UNITED STATES PATENT AND TRADEMARK OFFICE

APPLICATION NO.	FILING DATE	FIRST NAMED INVENTOR	ATTORNEY DOCKET NO.	CONFIRMATION NO.
10/673,485	09/30/2003	Jeong-Hee Lee	1594.1095D	1531
21171	7590	06/18/2004	EXAMINER	
STAAS & HALSEY LLP SUITE 700 1201 NEW YORK AVENUE, N.W. WASHINGTON, DC 20005			VAN, QUANG T	
			ART UNIT	PAPER NUMBER
			3742

Office Action Summary	Application No. 10/673,485	Applicant(s) LEE, JEONG-HEE	
	Examiner Quang T Van	Art Unit 3742

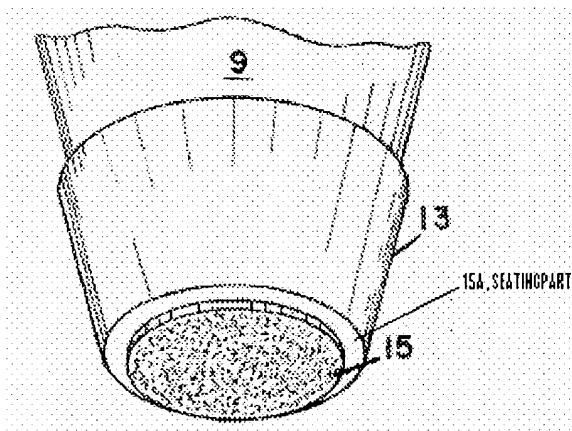
4. Claims 1 and 2 are rejected under 35 U.S.C. 102(b) as being anticipated by Uchanski et al (US 3,847,324). Uchanski discloses a non-tipping, disposable dishware having a saucer (13) comprising a cup seating part (15A, figure below) having a disc shape; and an engaging part (15) to removably engaging with a saucer holder (16) provided on the microwave oven.
